City of Portland, Maine - Building or Use Permit Application 389 Congress Street, 04101, Tel: (207) 874-8703, FAX: 874-87

BUILDING PERMIT REPORT

DATE: 8/19/96 ADDRESS: Lyndon Ave, Peaks Is 89A-5
REASON FOR PERMIT: to make interior/external renovating
BUILDING OWNER: Gyle Burton
CONTRACTOR: Burton Const. APPROVED: with conditions
PERMIT APPLICANT: Contractor DENIED: # 1, 7, 9, 14, 16

1st Floor master plan

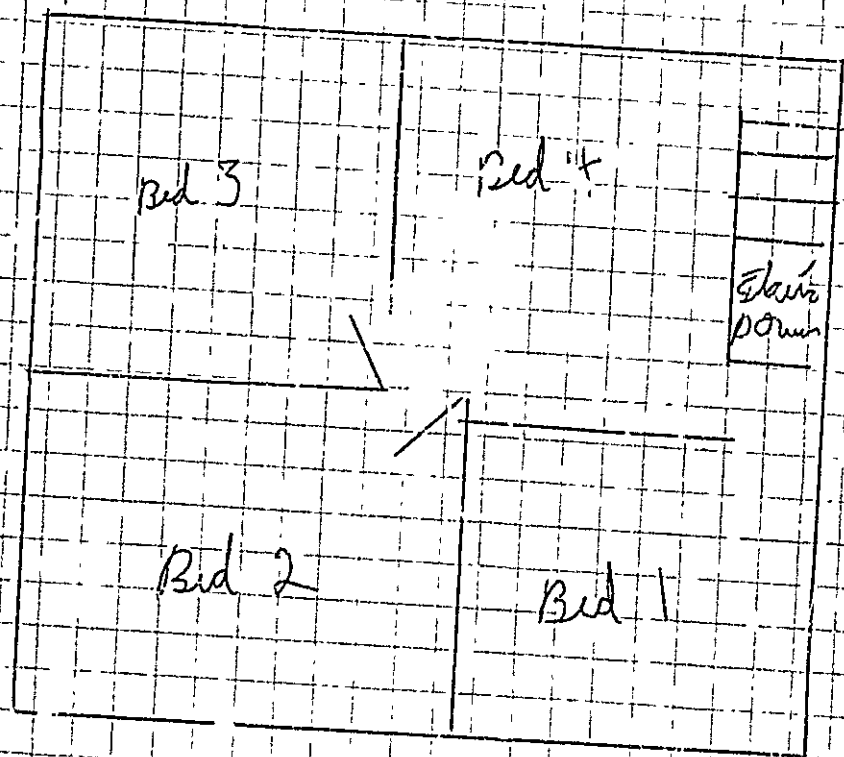
7. Every sleeping room below fourth story in buildings of Use Groups R and I-1 shall have at least one operable window or exterior door approved for emergency egress or rescue. The units must be operable from the inside without the use of special knowledge or separate tools. Where windows are provided as means of egress or rescue, they shall have a sill height not more than 44 inches (1118mm) above the floor. All egress or rescue windows from sleeping rooms shall have a minimum net clear opening height dimension of 24 inches (610mm). The minimum net clear opening width dimension shall be 20 inches (508 mm), and a minimum net clear opening of 5.7 sq. feet.

8. A portable fire extinguisher shall be located as per NFPA §10. They shall bear the label of an approved agency and be of an approved type.
9. All single and multiple station smoke detectors shall be of an approved type and shall be installed in accordance with the provisions of the City's building code Chapter 9, section 19, 919.3.2(BOCA National Building Code/1993), and NFPA 101 Chapter 18 & 19. (Smoke detectors shall be installed and maintained at the following locations):

14. Headroom in habitable space is a minimum of 7'6".
15. The minimum headroom in all parts of a stairway shall not be less than 80 inches.
16. All construction and demolition debris must be disposed at the city's authorized reclamation site. The fee rate is attached. Proof of such disposal must be furnished to the office of Inspection Services before final certificate of occupancy is issued or demolition permit is granted.
